PERMIT

SEWAGE DISPOSAL SYSTEM
HOWARD COUNTY HEALTH DEPARTMENT
BUREAU OF ENVIRONMENTAL HEALTH
410-313-2640

PROPERTY DIVISION Peacefields @ Cattail Creek LOT NUMBER 3 ADDRESS 15528 Cattail Oaks

0515050-C

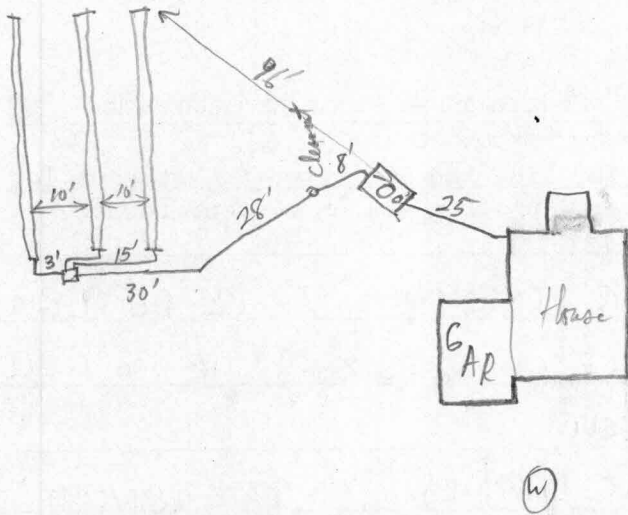
PRE-CONSTRUCTION INSPECTION: 4/19/01 - TELEPHONE CONVERSATION W/INSTALLER, INSTALLER REPORTS

AN INLET AT 2', BOTTOM AT 4' CANNOT WORK BECAUSE OF CONTOUR, I TOLD HIM THE PERCS. DO NOT ALLOW TO DROP THE SYSTEM MUCH BUT A BOTTOM OF 5' AND INLET AT 3' WOULD BE OK IF THIS IS INSPECTION COMMENTS: NOT POSSIBLE: A PUMP SYSTEM IS REQUIRED (SRK) 5/30/01 Contour

not as shown on BP plan. To install 3 long trenches towards 157.18' lot line. To try to stay out of low area near house - 5' trench depth, 7' spacing. S.T., House Connection OK, Dist Box OK, Trench OK, OK to Overall work. RPP 6/13/01
